SEWAGE DISPOSAL SYSTEM

DEPARTMENT OF HEALTH AND MENTAL HYGIENE

A REPAIR

SUBDIVISION _____ LOT _____ ROAD 11285 Old Frederick Road

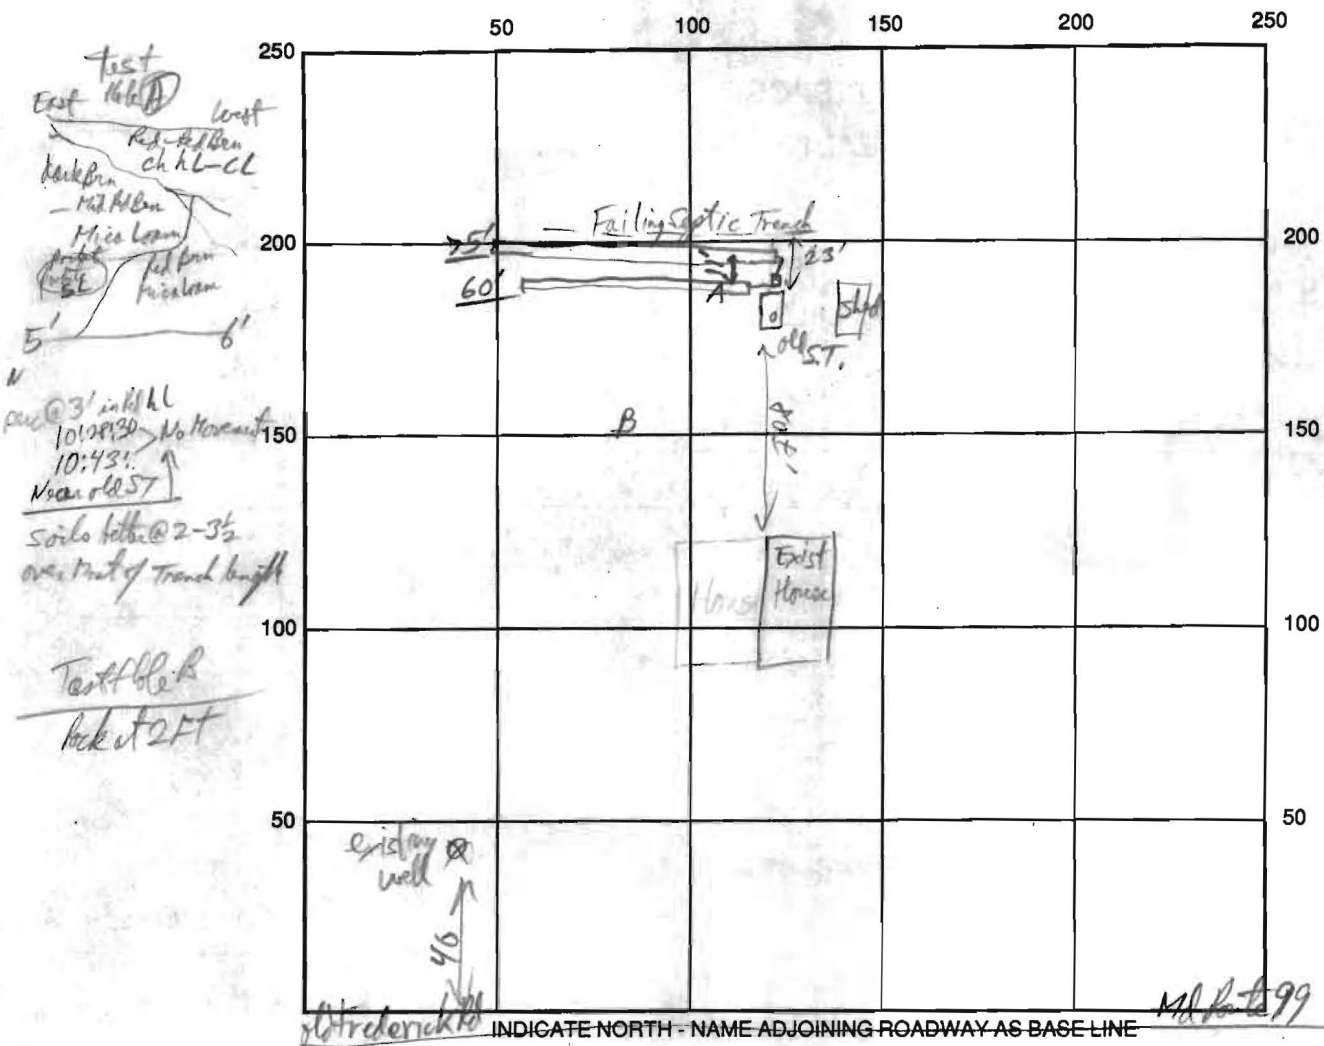
Install 2 trenches about 20' each (straget - 60' min) - Trenches shallow, inlet @ 2', Bottom @ 3 1/2 ft, 18" gravel fill, 3 ft wide because of water seepage @ 5 ft. Existing Septic Tank is ok. J.P. [Signature] 8/23/94

REMARKS: Limiting ground water seepage at 5-6 ft in bottom of observation
Trench A. Shallow trenches OK most of length - OK to love 8/23/94 PJP

SEPTIC TANK LEVEL existing 100gal CLEANOUTS S.T. + dist. Box. ✓
 DISTRIBUTION BOX LEVEL ✓
 DRAIN FIELD/TITLE DEPTH 3 1/2 FT. TRENCH WIDTH 3 FT. INLET DEPTH 2 FT.
 EFFECTIVE GRAVEL DEPTH 1 1/2 FT. TOTAL LENGTH 60/75 FT.
 NUMBER OF TRENCHES 2 ONE SIDEWALL/BOTTOM AREA 405 SQ. FT.
 DRYWALL INSIDE DIAMETER _____ FT. EFFECTIVE DEPTH BELOW INLET _____ FT.
 ABSORBENT AREA _____ SQ. FT.
